MB Knit Fashion Ltd.

6th September, 2016

Observations

Generator Building

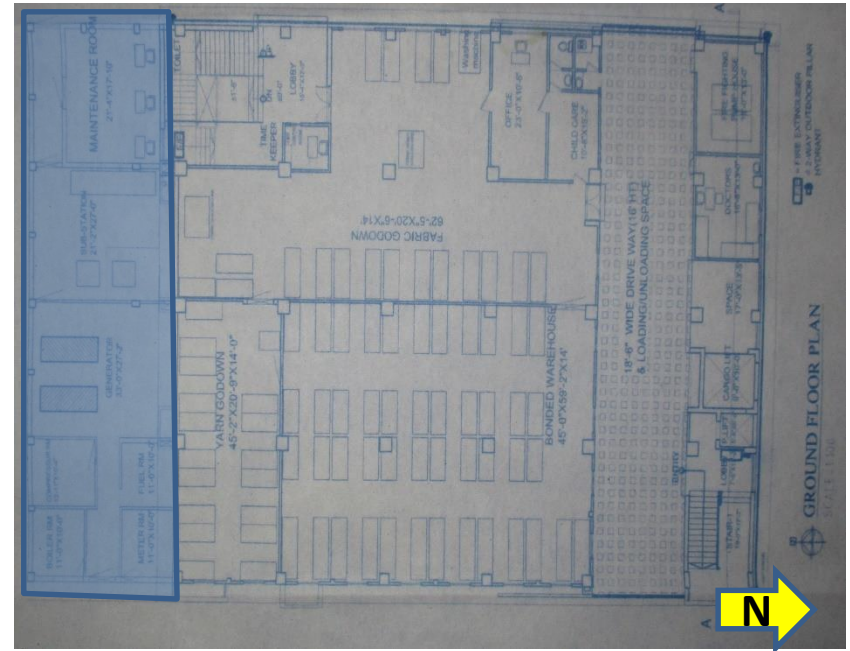
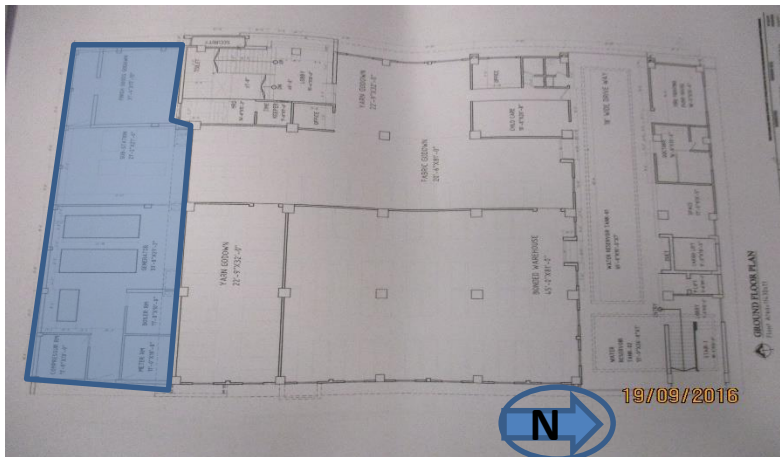
**As- Built Drawing of Generator Building was
not available**

No detail drawing(As build structural)
was found during inspection.

As- Built Drawing of Generator Building was not
available

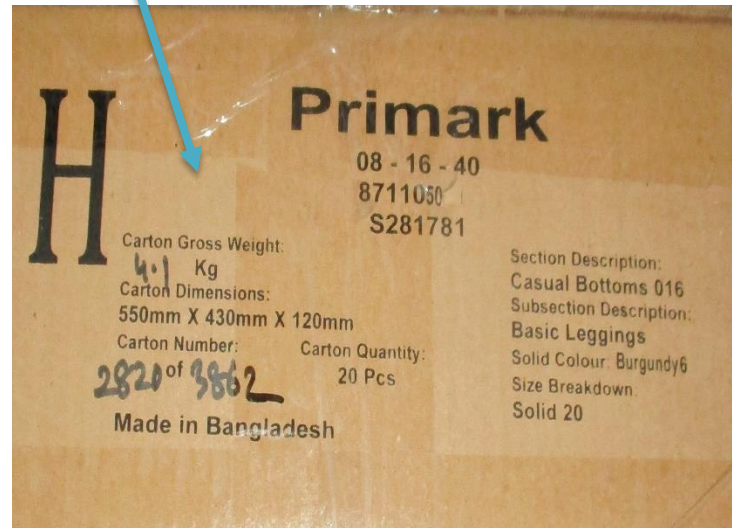
Uncontrolled loading on floor area

High Loading observed on 6th Floor

High Loading observed on 2nd Floor

Uncontrolled loading on floor area

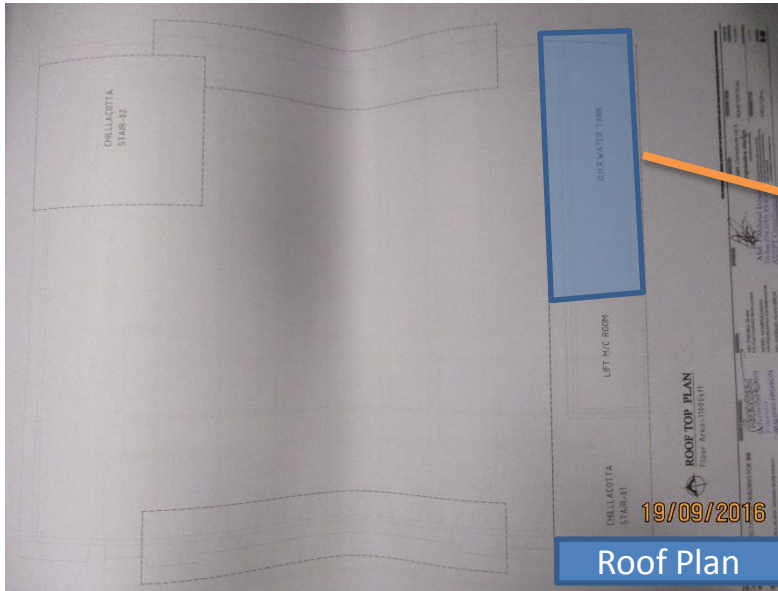
Construction Material observed on
roof

Uncontrolled loading on floor area

Dampness found on the bottom slab of RCC water tank
